ADDENDUM #1

FISHBECK ADDENDUM NO. 1

Well Station 11 Filter Improvements

91392-003.0

CONCRETE SUPPORT FOR ELBOW DETAIL
 NO SCALE

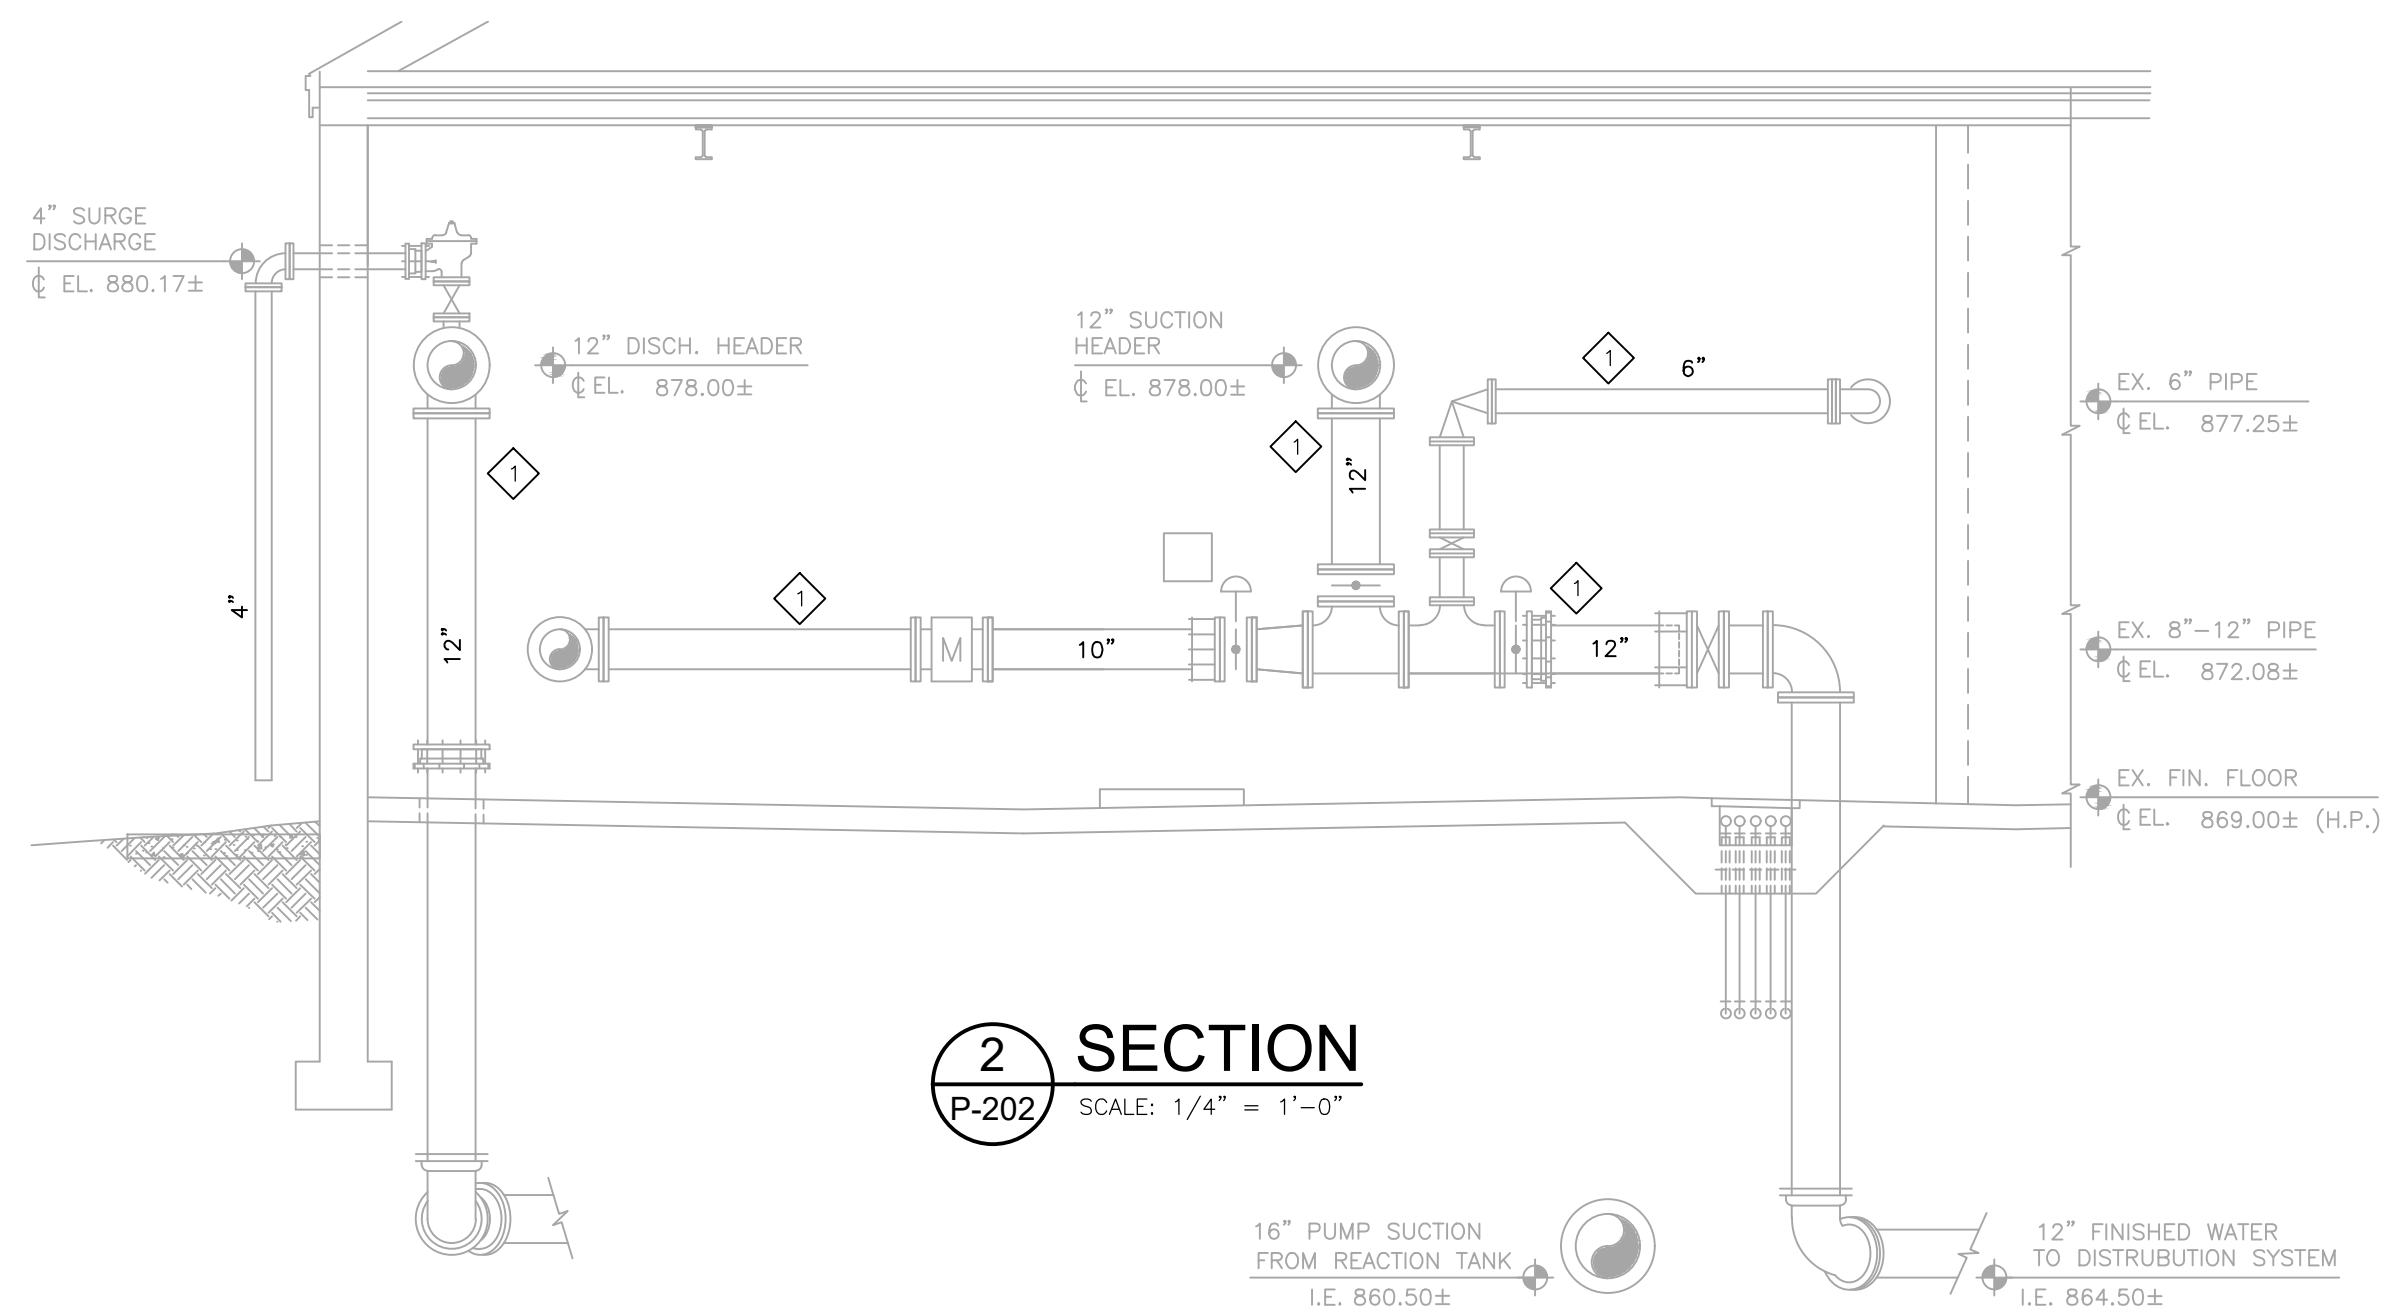
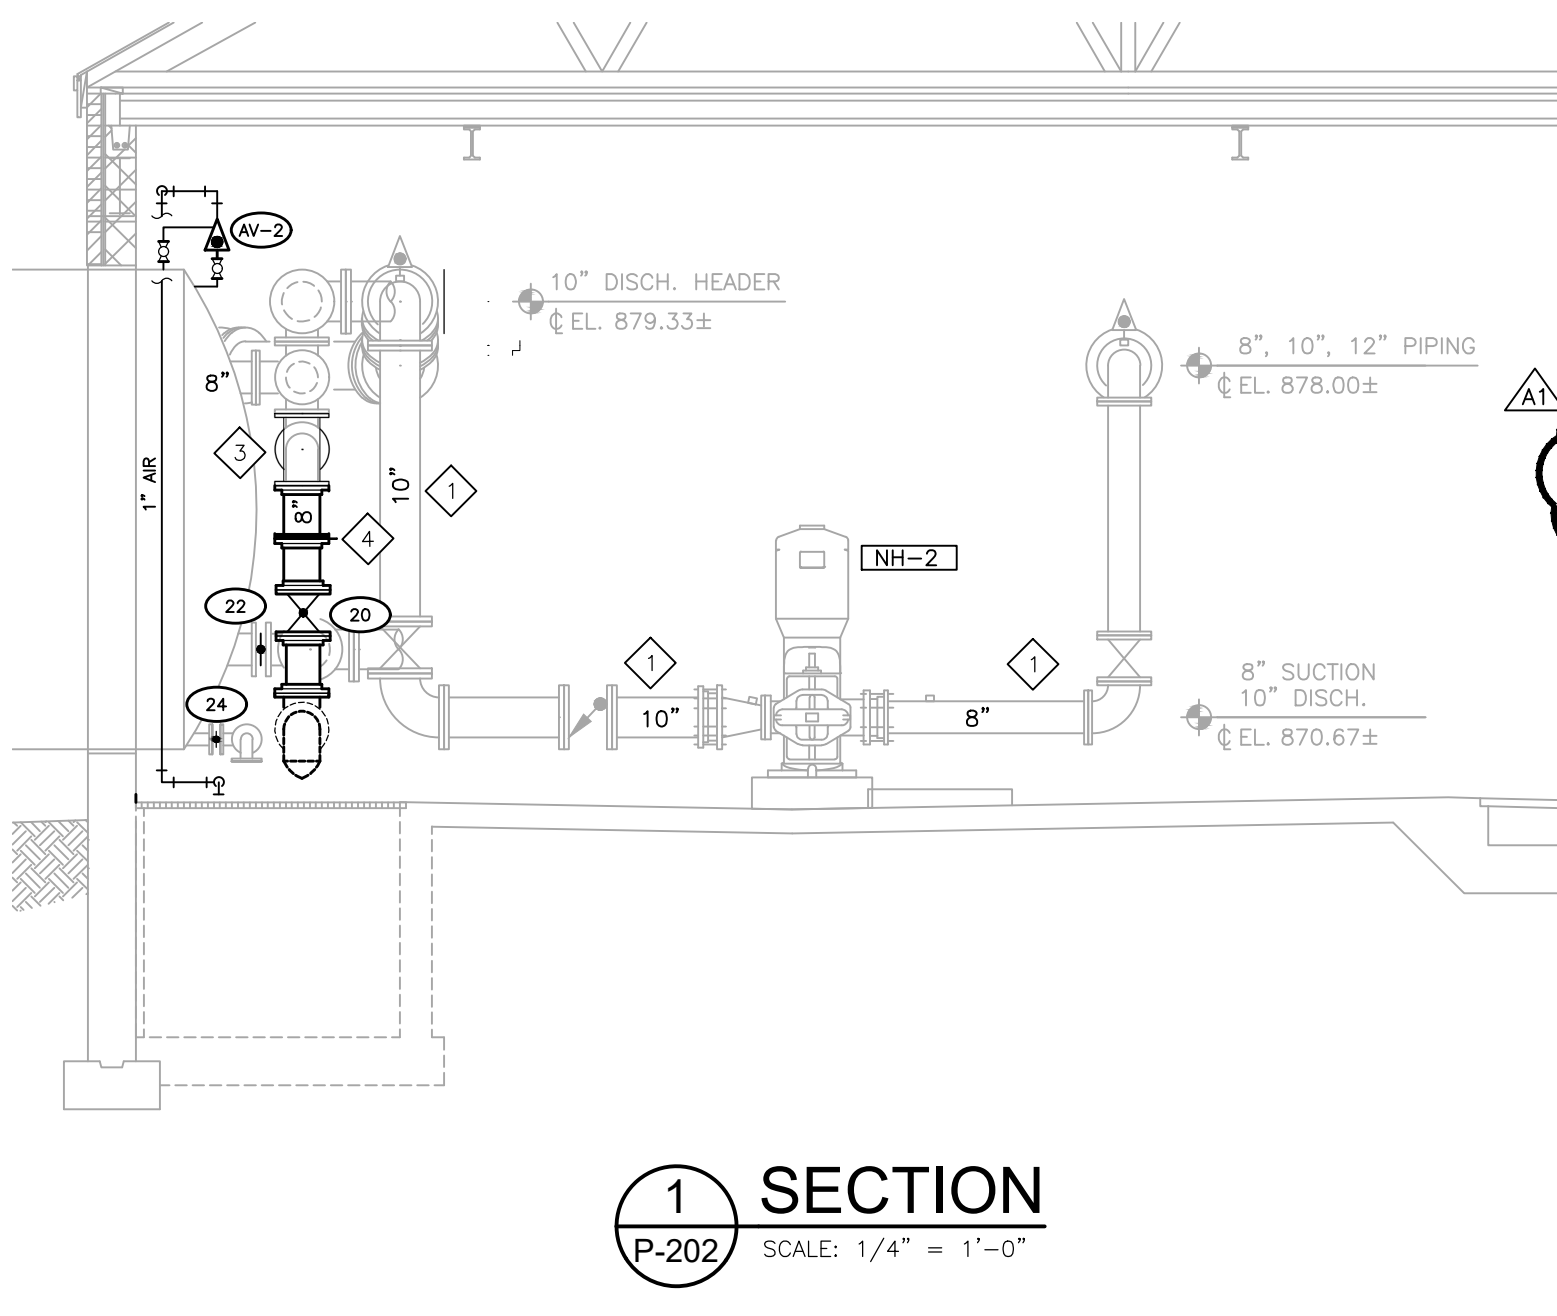
A. Add Keynote 11:

11. Relocate and reconnect three existing electrical conduits and conductors in this area where new 8" pipe is routed. Coordinate with City on shutdown of equipment these conductors supply during work.

11. RELOCATE AND RECONNECT THREE EXISTING ELECTRICAL CONDUITS AND CONDUCTORS IN THIS AREA WHERE NEW 8" PIPE IS ROUTED. COORDINATE WITH CITY ON SHUTDOWN OF EQUIPMENT THESE CONDUCTORS SUPPLY DURING WORK.
